1. SUBMITTAL TYPE: (Is this a resubmittal? Yes ☐ No ☒)			
Deferred Submittal ☐	Addendum Number: 01	Revision Number:	CCD Number: Category A ☐ or B ☐
2. PROJECT INFORMATION:			
School District/Owner: San Beranrdo City USD		DSA File Number: 36 H7	
Project Name/School: Indian Springs HS - Health Center		DSA Application Number 04 123900

ADDENDUM NO. 1

Indian Springs High School – Health Center

DSA #04-123900 FILE #36-H7 RCA Project No. 1-78-50

MECHANICAL REMODEL FLOOR PLAN

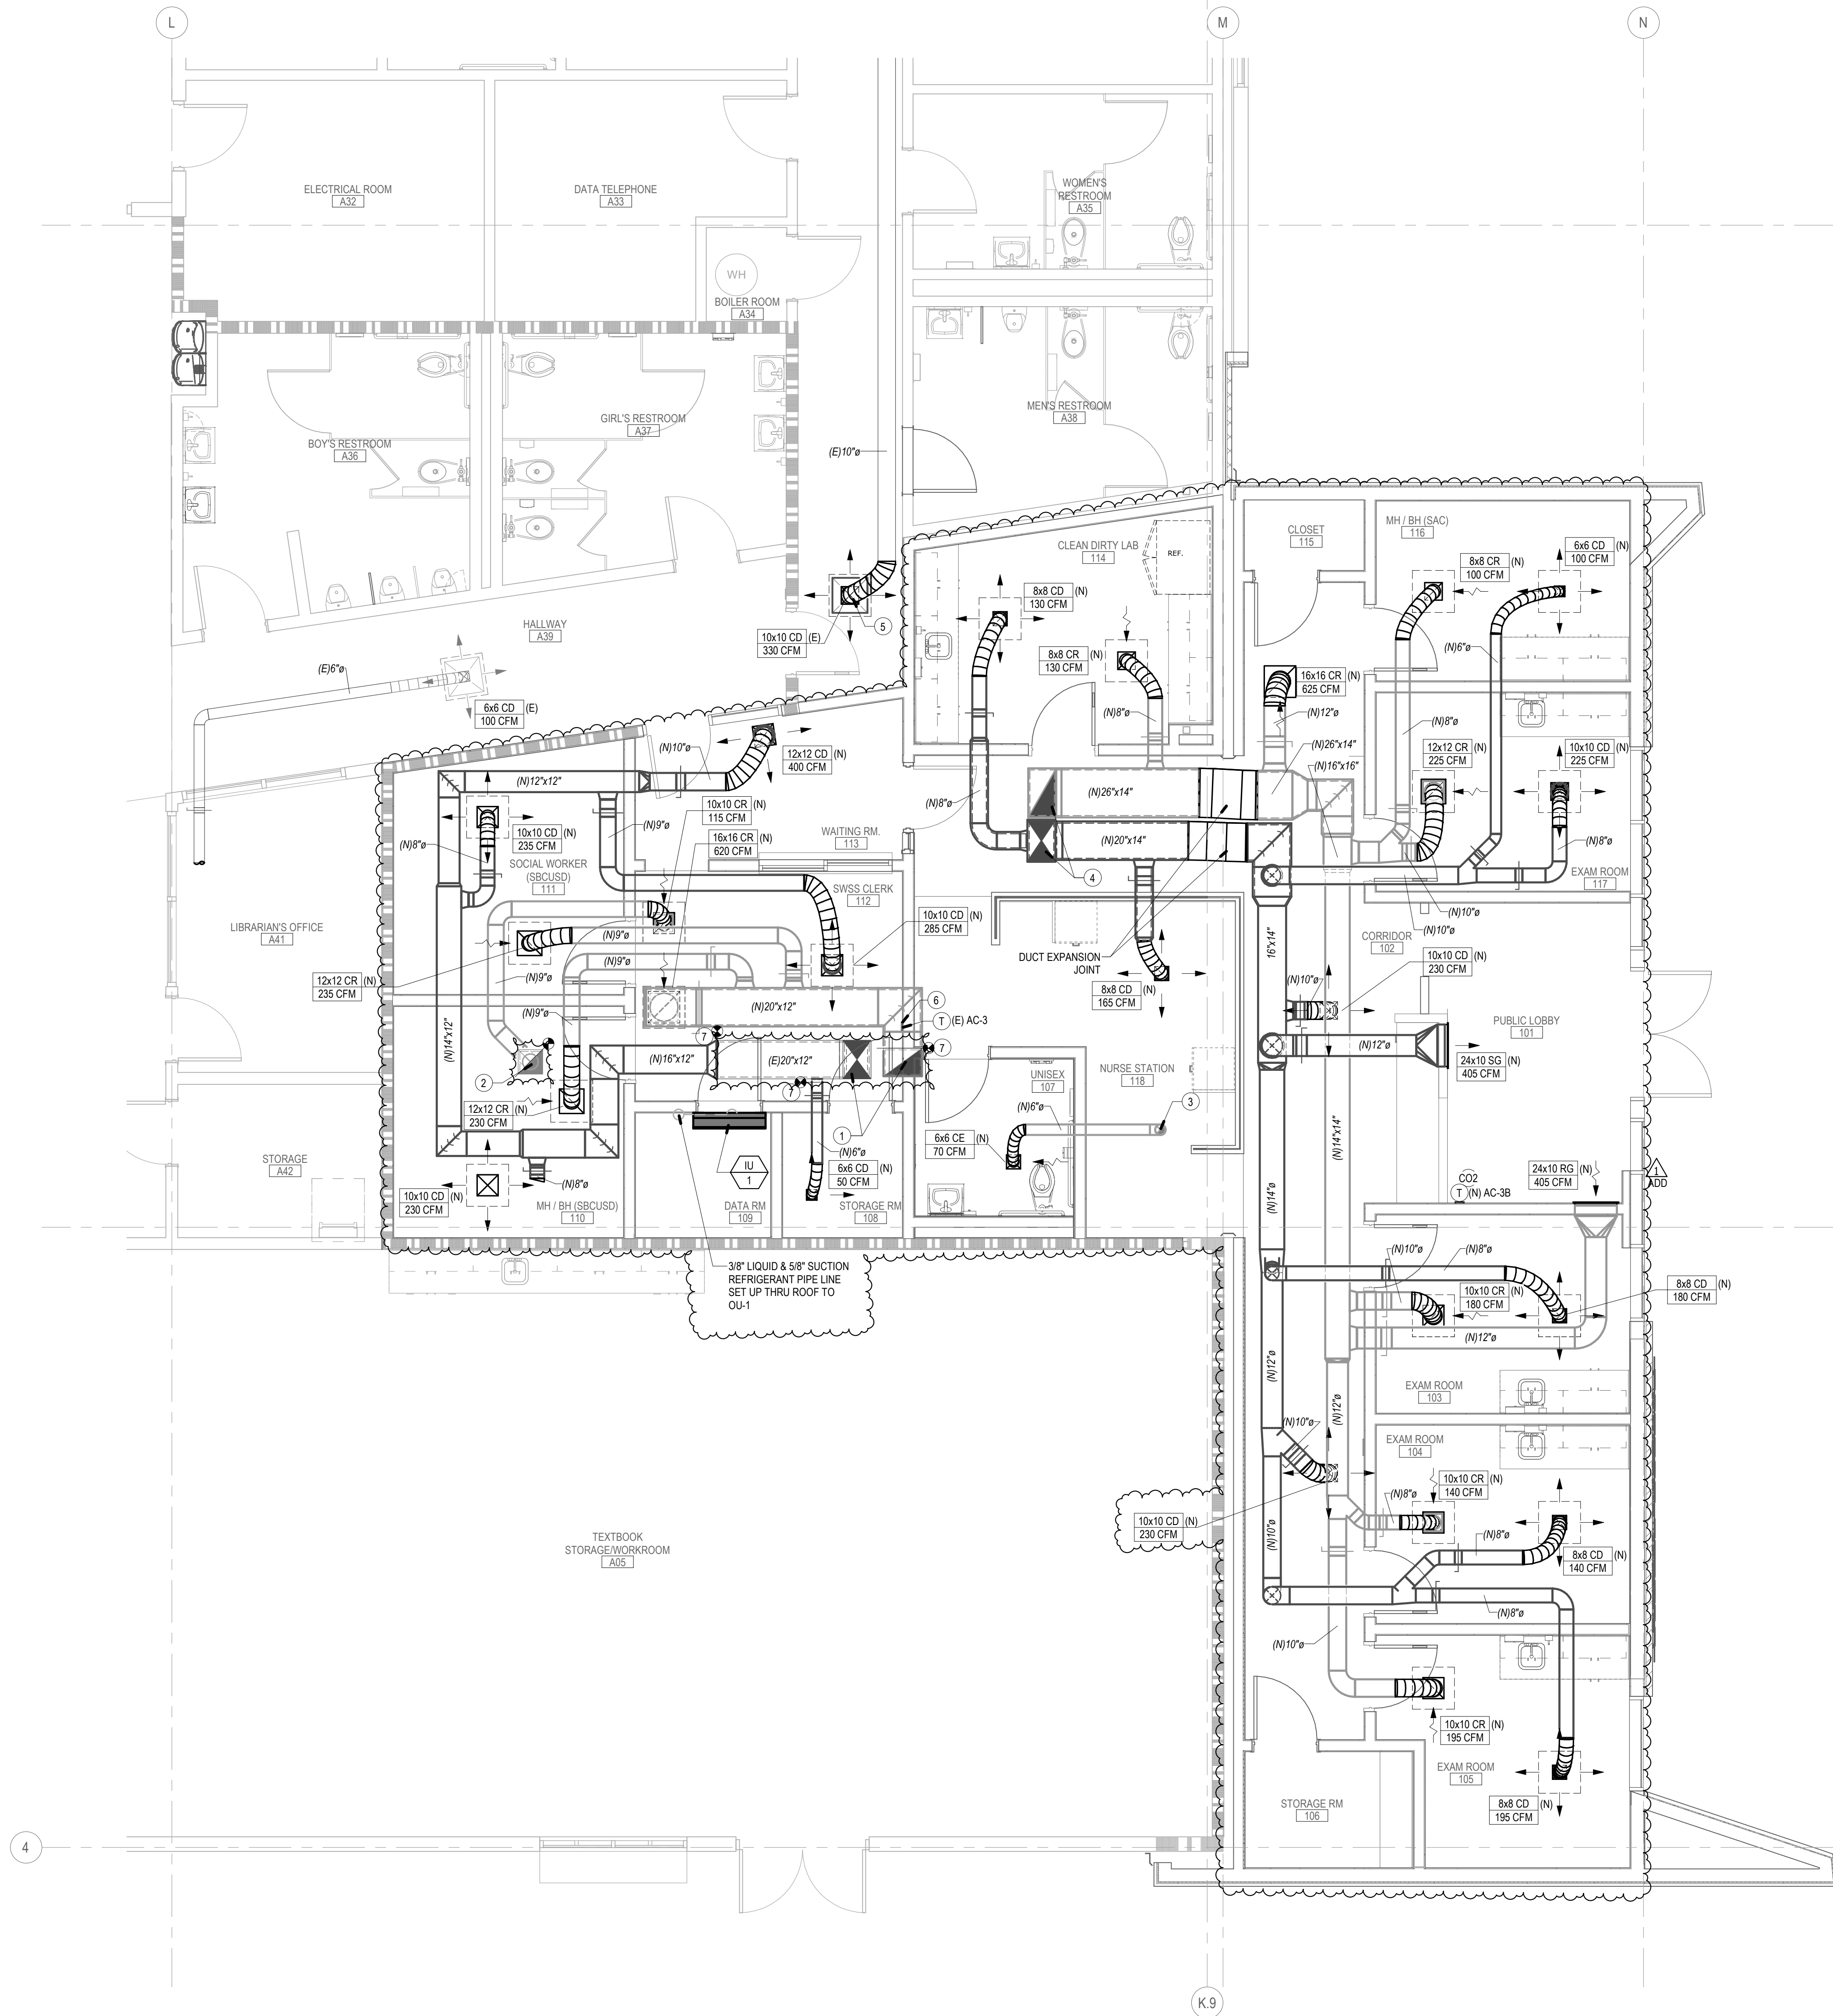
Item No. 1.31 Reference Sheet M1-1.1 - MECHANICAL REMODEL FLOOR PLAN
1.31.1 Replace Sheet M1-1.1 and revise per clouded areas & items listed below:
 (a) Revised air distribution for AC-3 and AC-3B
 (b) Revised location of existing thermostat for AC-3
 (c) Revised location of new thermostat and CO2 sensor for AC-3B
 (d) Revised location of new exhaust duct thru roof
 (e) Added new IU-1 and refrigerant piping
 (f) Added new general notes #15 & #16

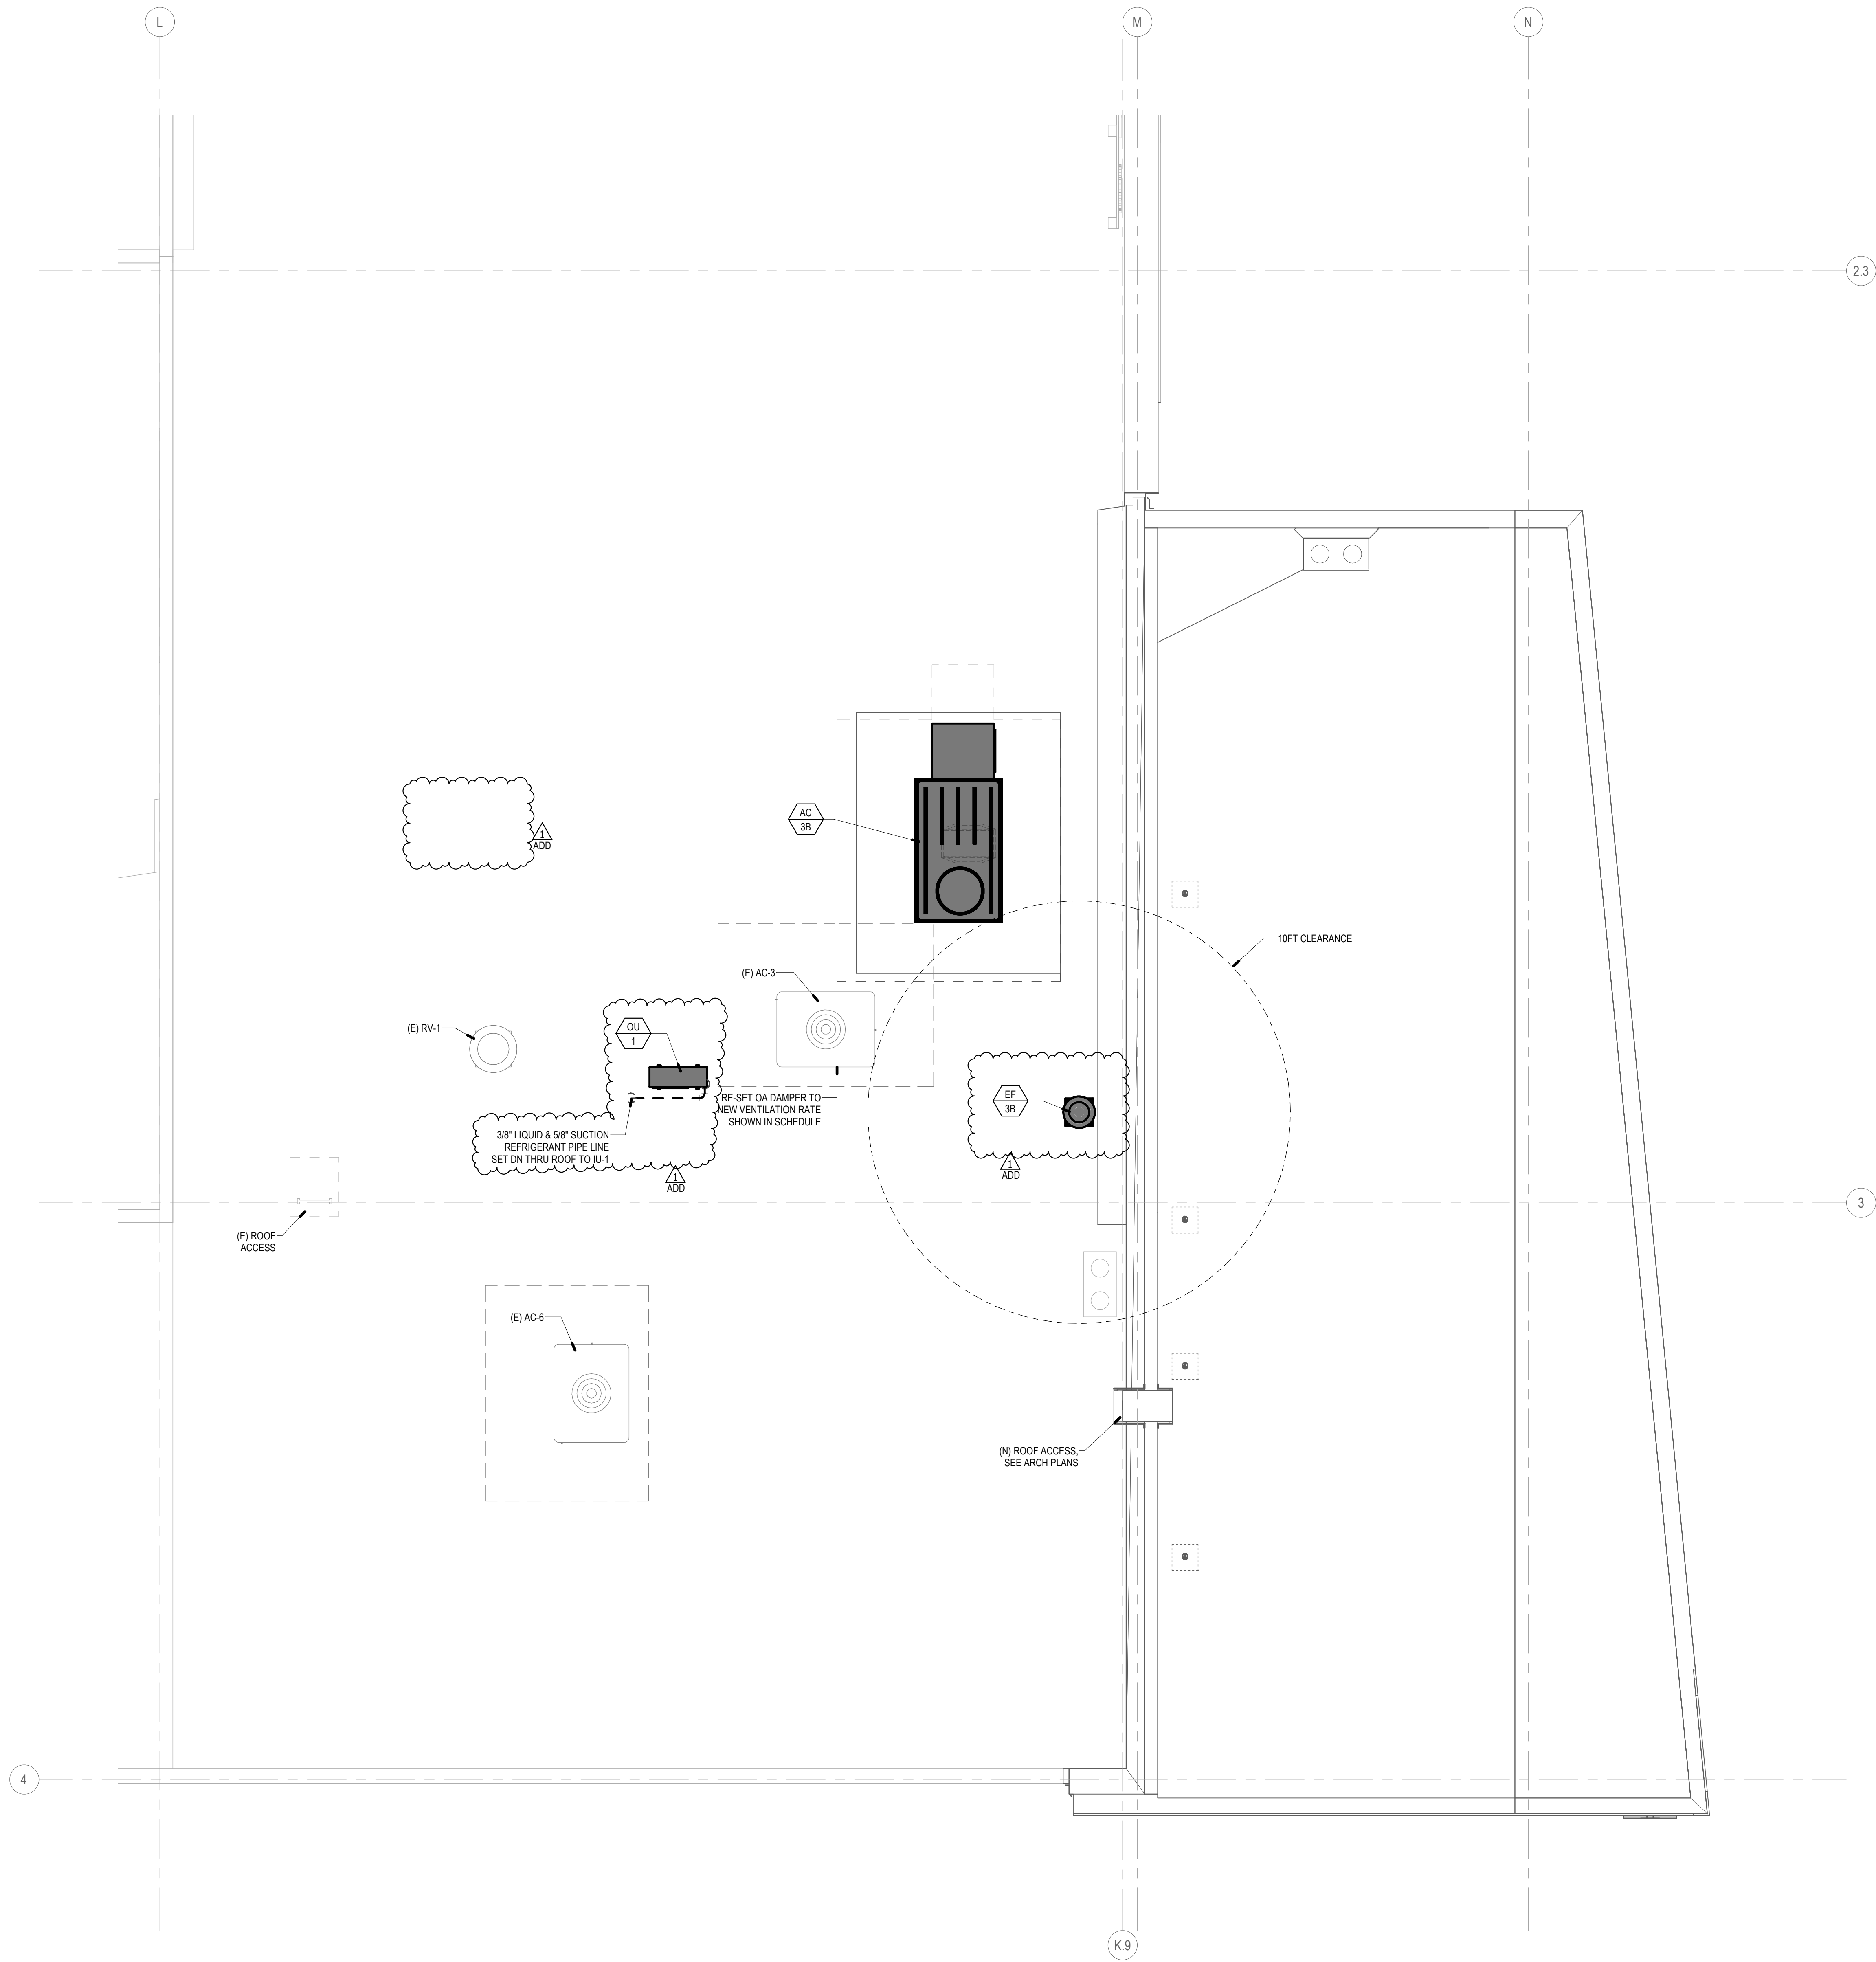
Item No. 1.32 Reference Sheet M1-2.1 - MECHANICAL REMODEL ROOF PLAN
1.32.1 Replace Sheet M1-2.1 and revise per clouded areas & items listed below:
 (a) Revised location of new EF-3B
 (b) Added new OU-1 & refrigerant piping
 (c) Added new general notes #5 & #6
